**Responses to NRC Letter Dated August 19, 1997 and December 5, 1997, Regarding NRC  
Acceptance Review of the Reclamation Plan for the White Mesa Uranium Mill**

**Source Material License SUA-1358  
Docket No. 40-8681**

**Response to Nuclear Regulatory Commission / White Mesa Mill Reclamation Plan  
Comments Dated August 19, 1997  
Source Material License SUA-1358**

**Response to Nuclear Regulatory Commission / White Mesa Mill Reclamation Plan  
Comments Received December 8, 1997  
Source Material License SUA-1358**

## Cell 2 Settlement Monitors

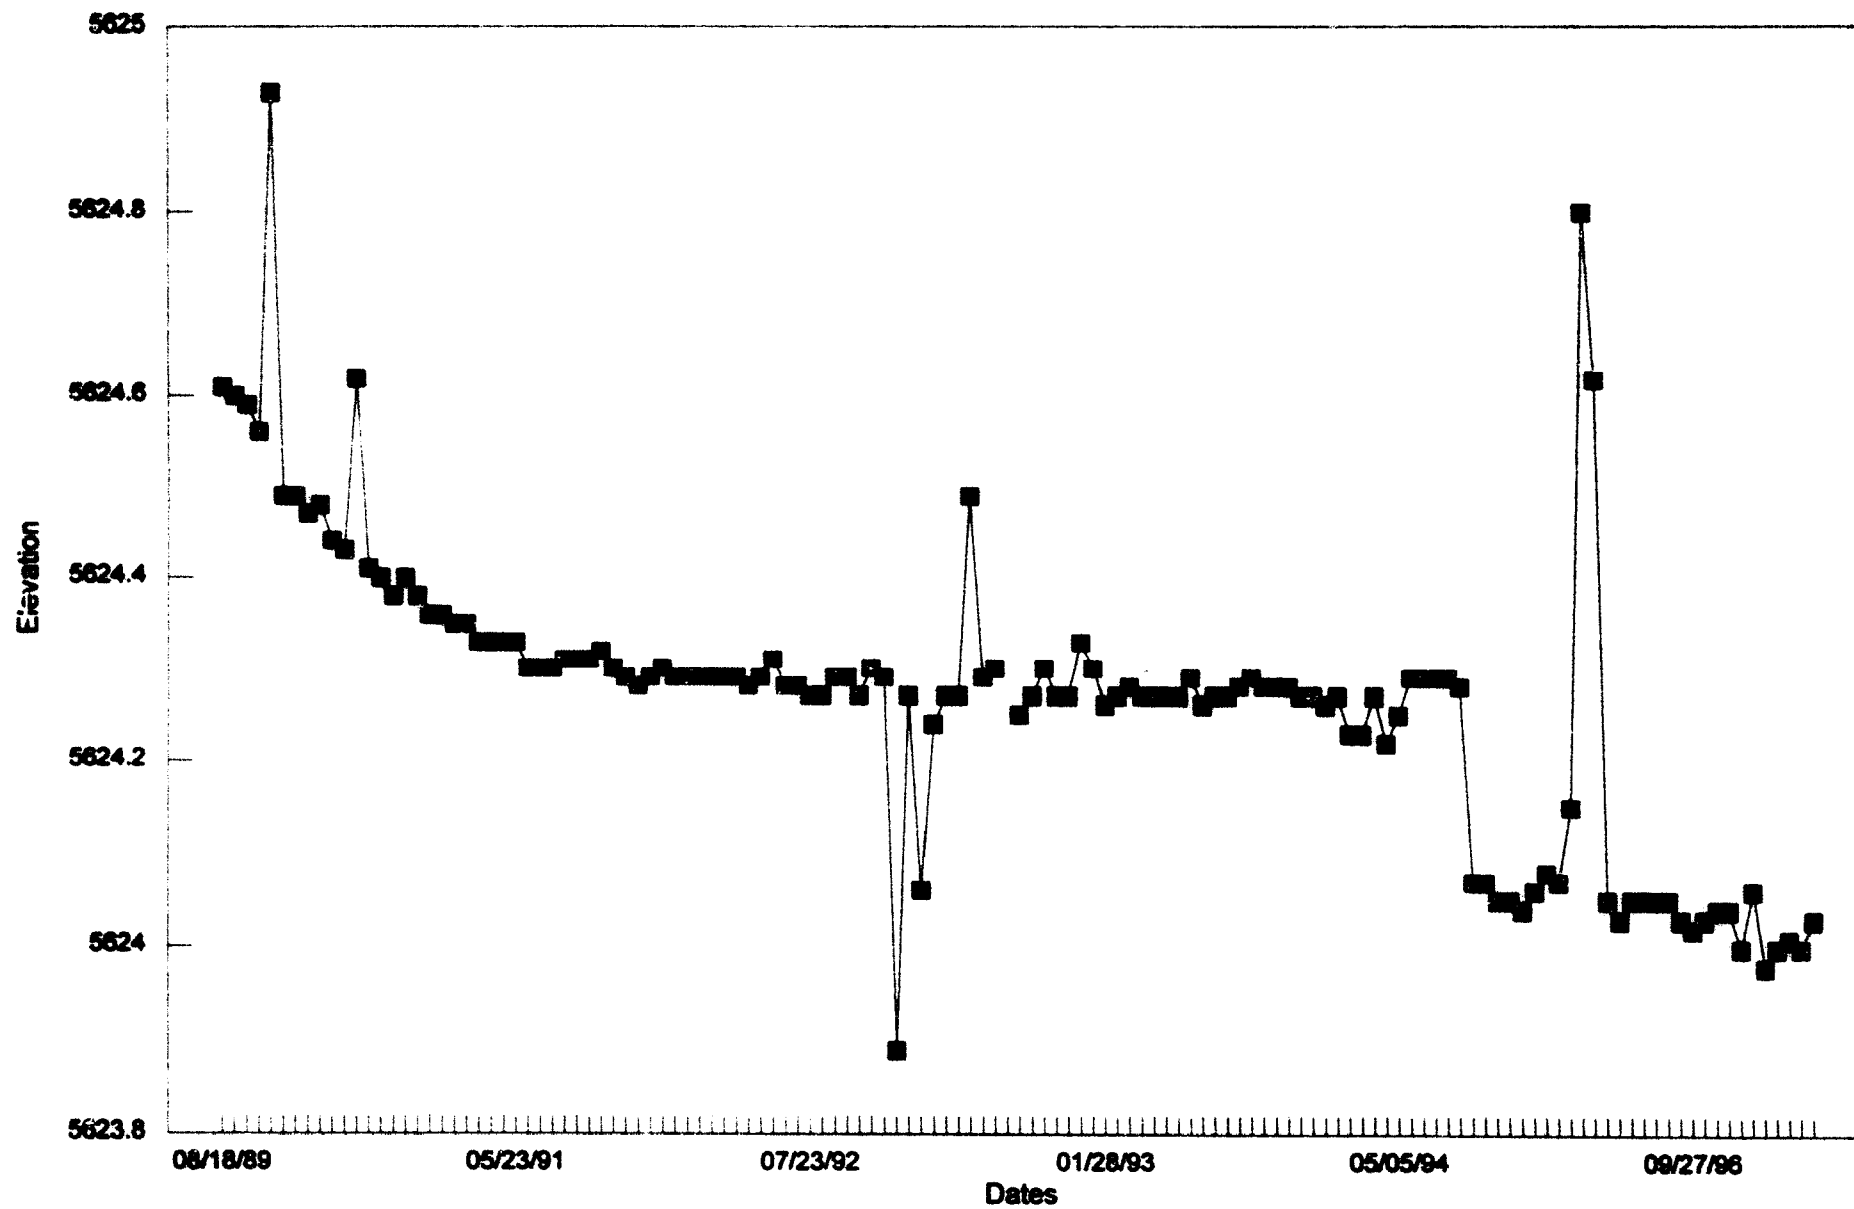
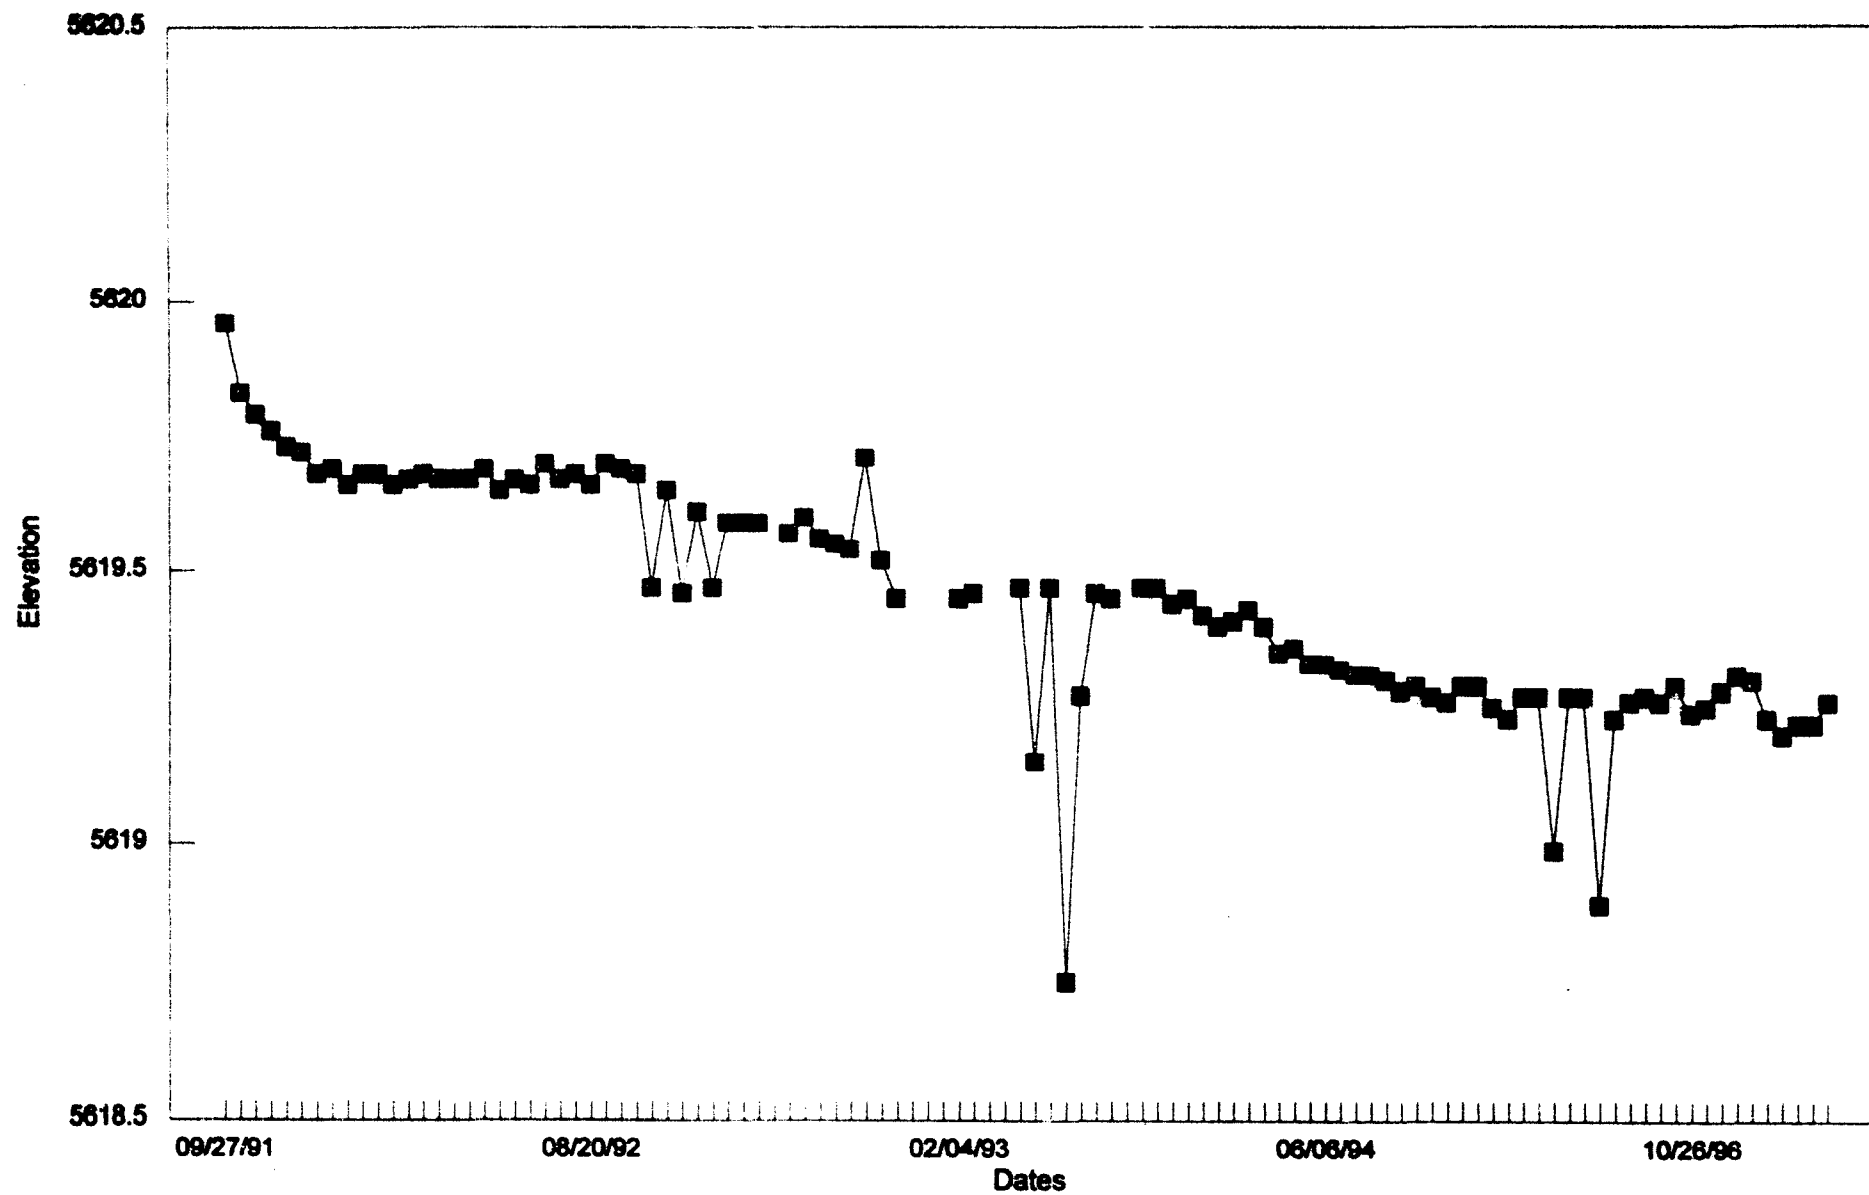
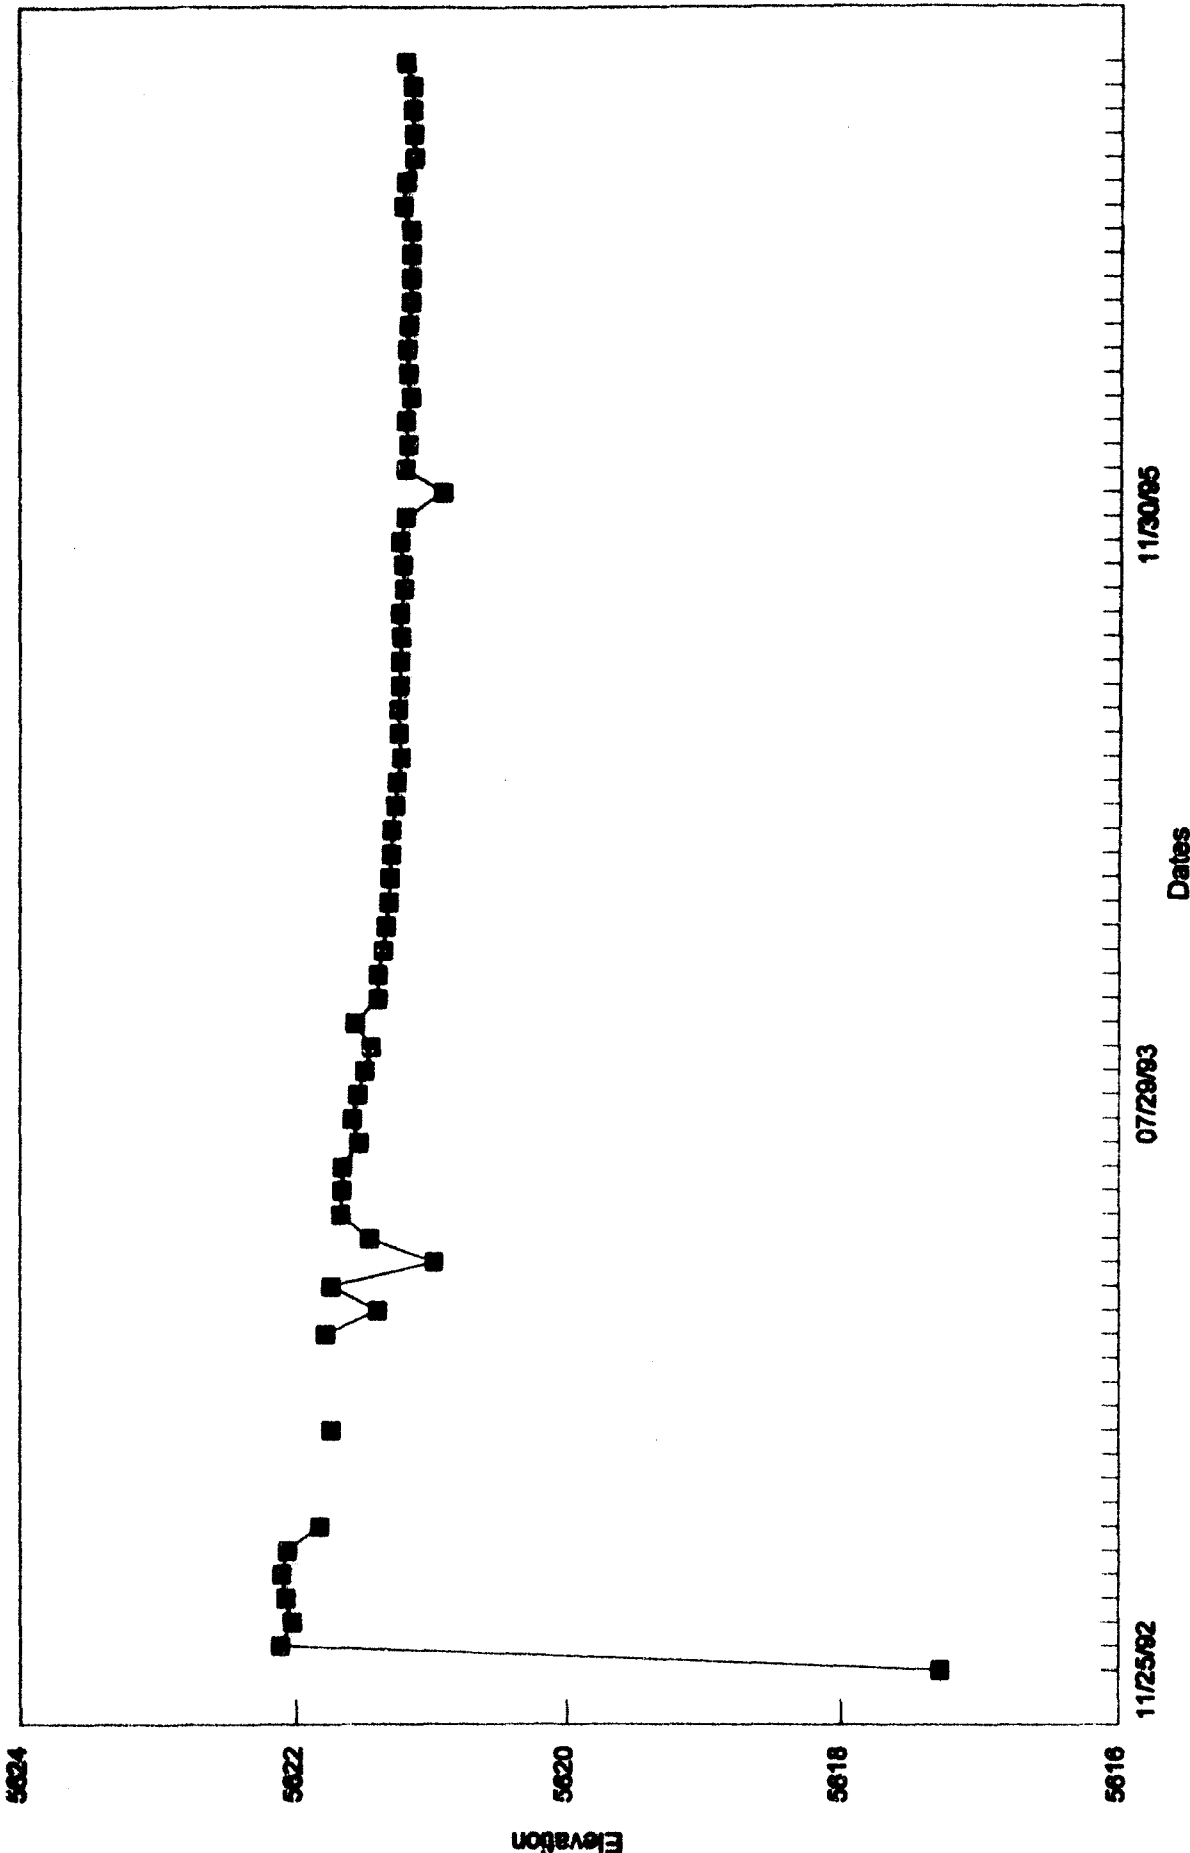
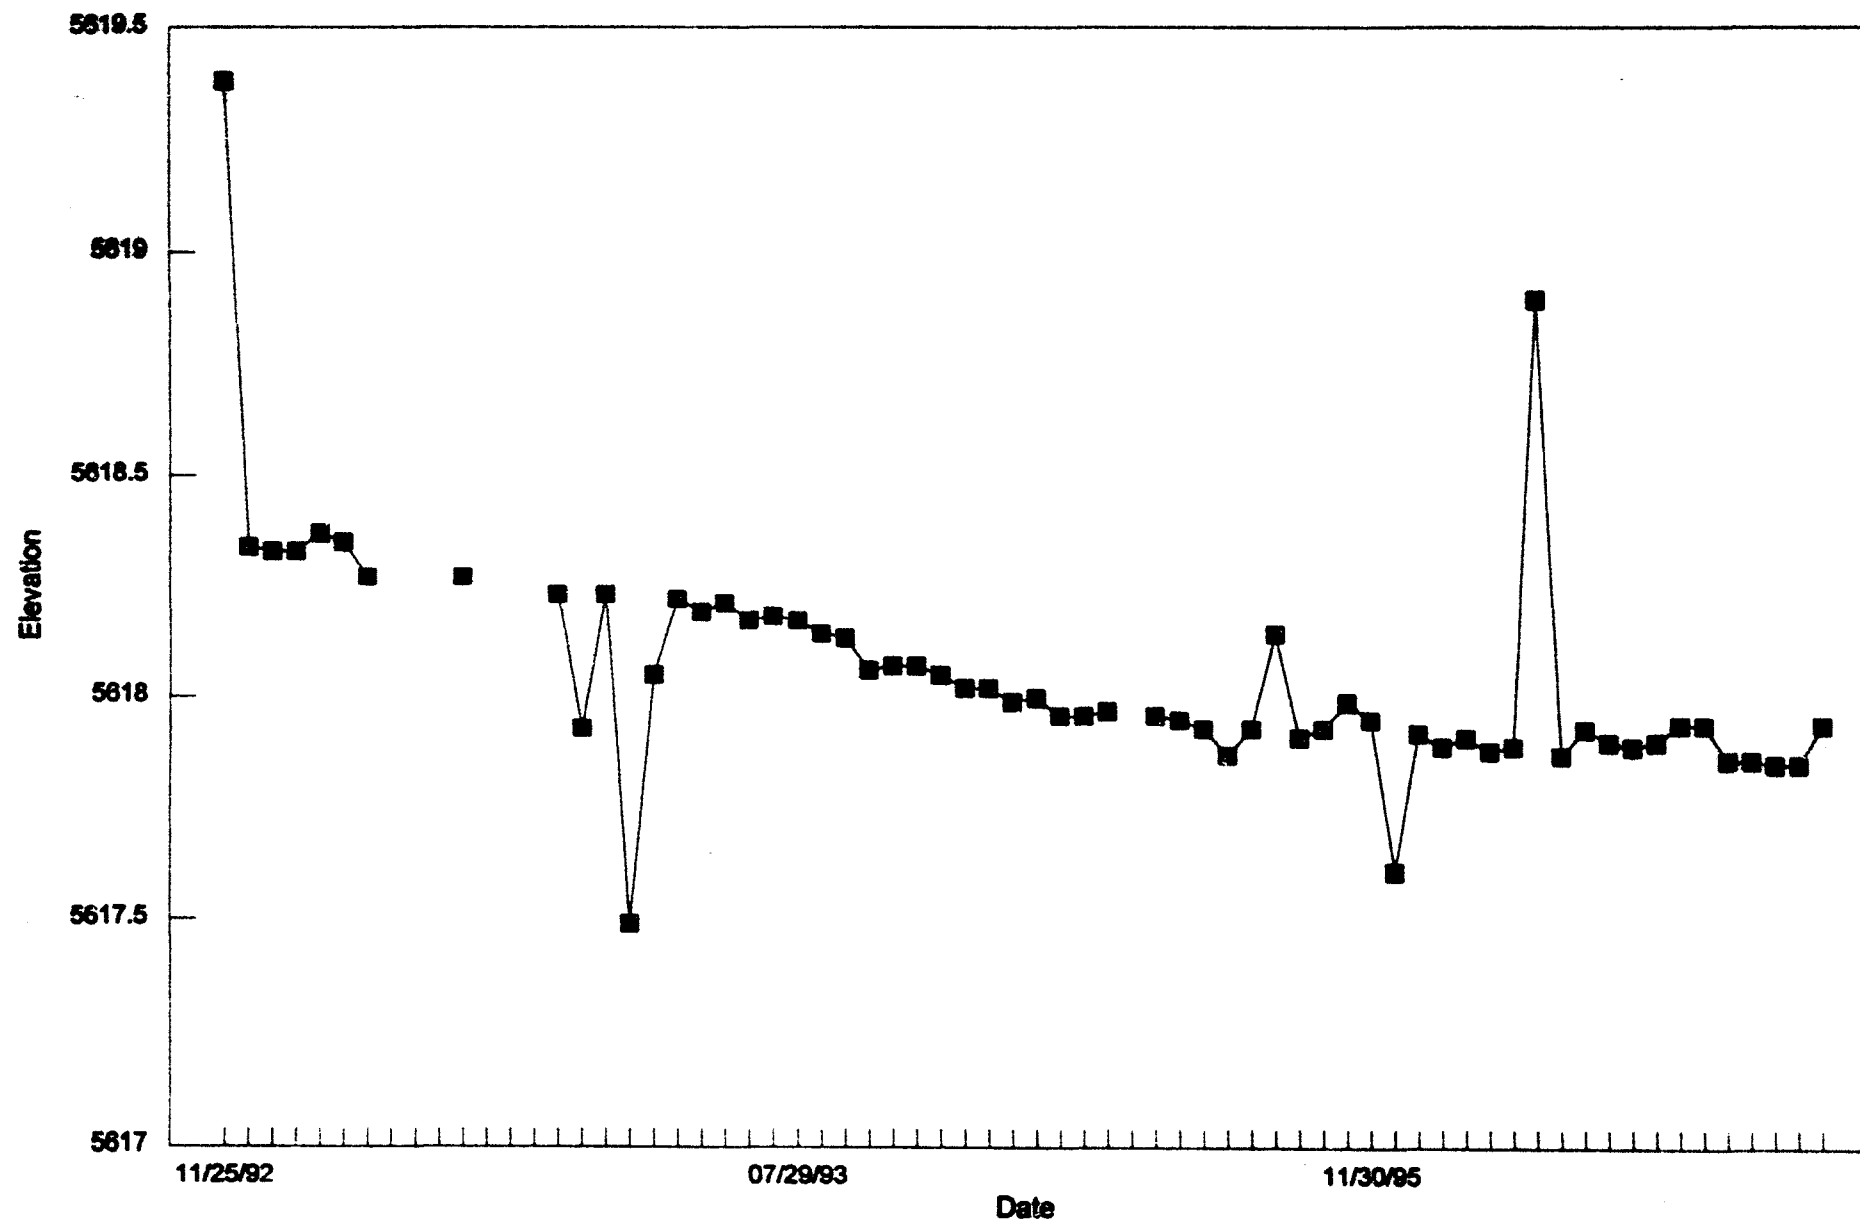
**(2) *An analysis of the total and differential settlements of the tailings surface and the effects of such settlements on soil cover integrity.***

Analysis of the total and differential settlement of the tailings surface was performed using the survey data compiled for the five settlement monuments installed within Cell 2. These monuments were installed on the surface of the tailings, between August 1989 and November 1992, prior to the placement of approximately three to four feet of random fill material. Survey results of each monument were plotted as time vs. settlement graphs and are presented in Attachment 2 of this response.

Review of the survey data and graphs shows that primary consolidation of the tailings has occurred, and the settlement rate has been very slow with minor total values. The maximum total settlement recorded is 0.97 feet, and the differential settlement is on the order of 0.50 feet. Approximately 81 percent of the total measured settlement occurred within the initial three years. Additionally, recent survey data indicates that the settlement has virtually stopped. From September 1995 to September 1997 the settlement averaged less than 0.03 feet per year, which is within the expectable survey error of 0.05 feet. This indicates that the settlement since 1995 is negligible.
